M/s.The Institute of Entrepreneurship Development
(Implementing Agency – Mecheri Handloom Cluster)

Tender for Construction of Industrial Work Shed Buildings and Amenities for the Common Facility Center of Mecheri Handloom Cluster

CORRIGENDUM-1 dated 09.04.2021

RESPONSE TO PREBID QUERIES

Gable frame Full sectional view details

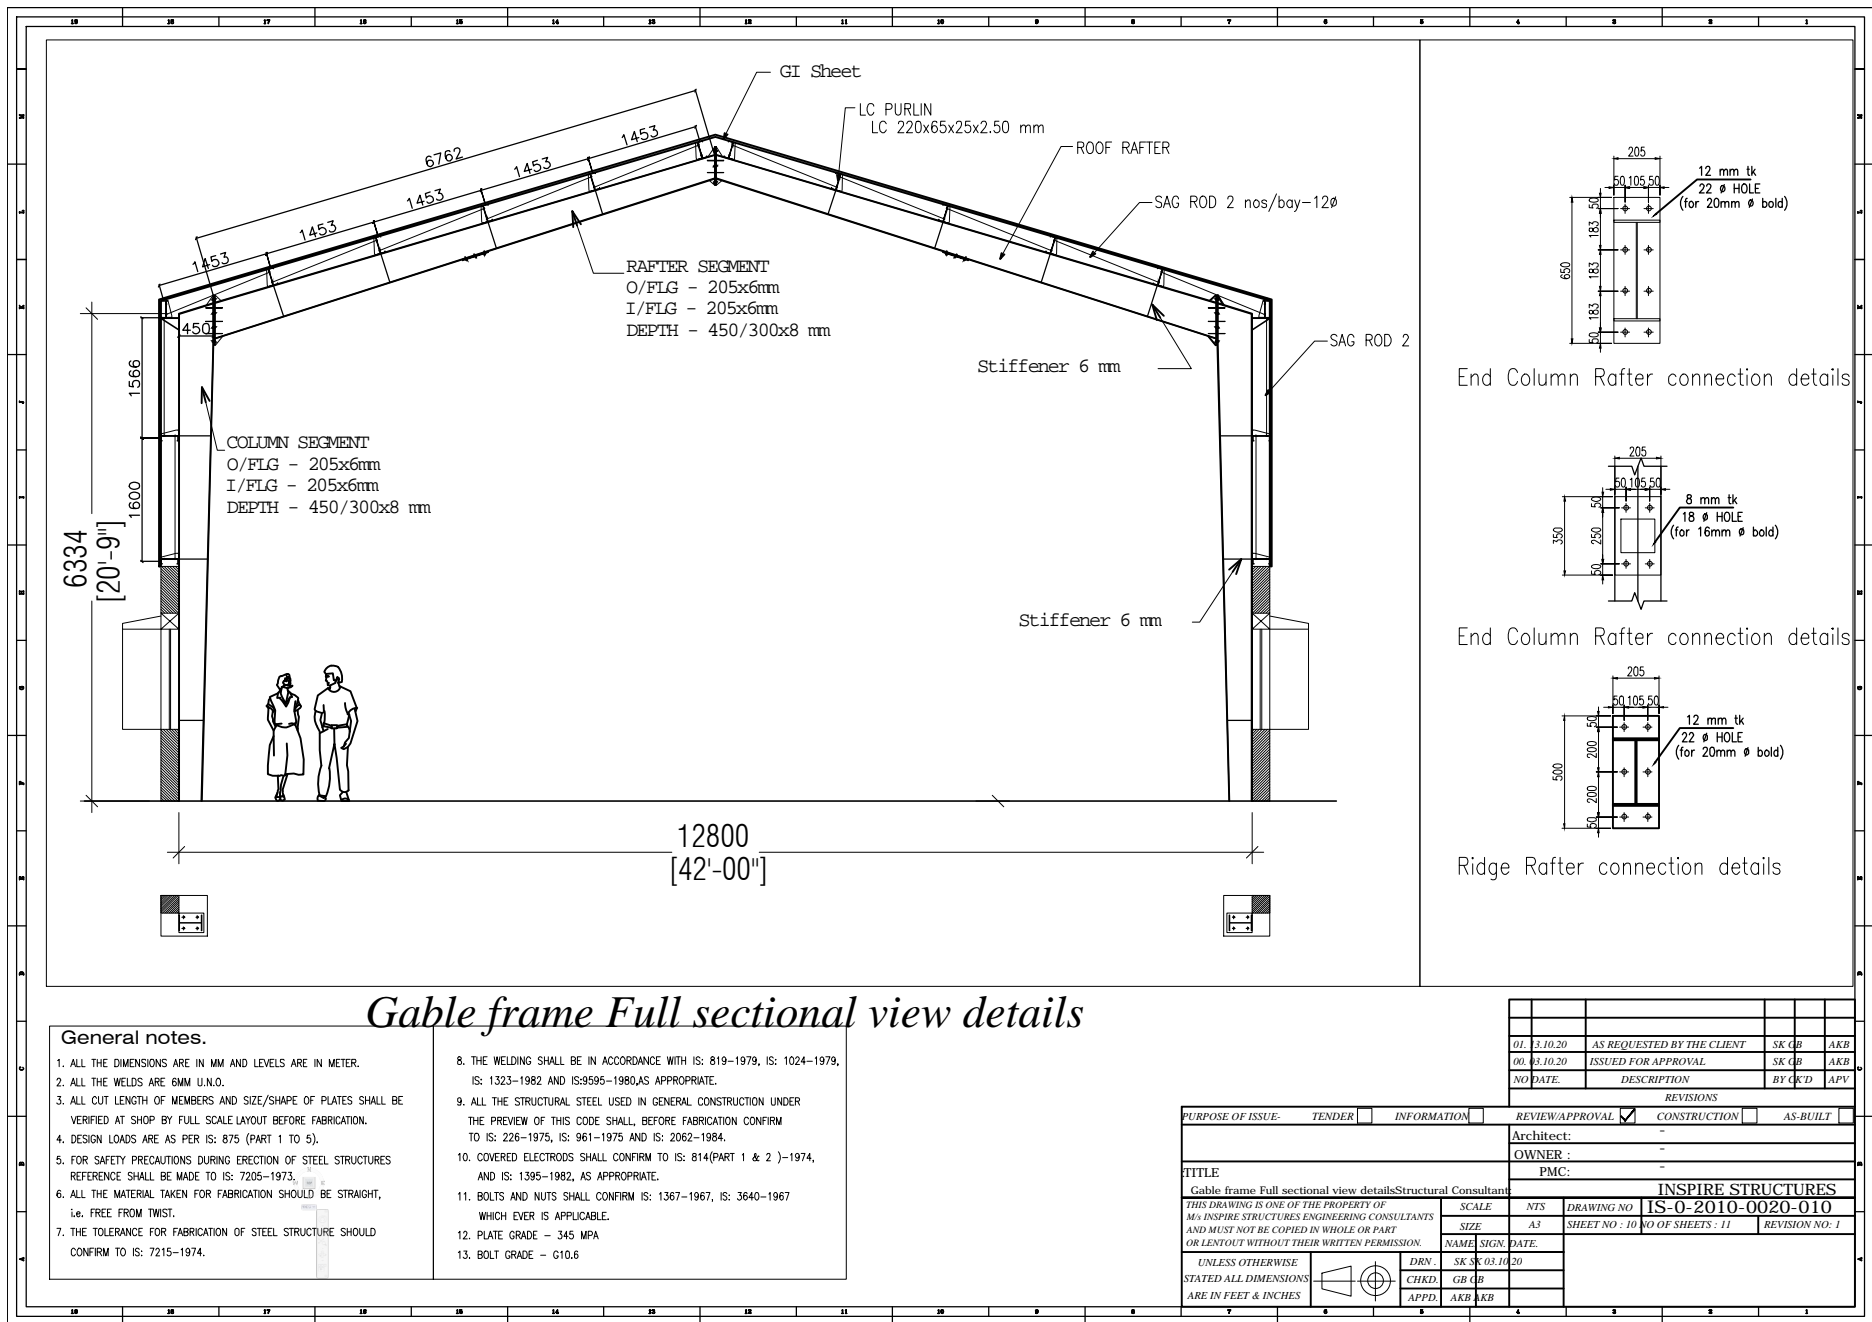
S.No	Page No	Clause No.	Existing Clause	Revised Clause
1.	13	Annexure – I	(To Add)	Drawing for the structural steel truss and steel column are included in Annexure I of tender document

2.	Page No.13 Drawing (Annexure – I)	Clear detailed drawing for the structural steel truss and steel column not given.	Drawing for the structural steel truss and steel column are included in the Tender document (Refer Corrigendum-1)
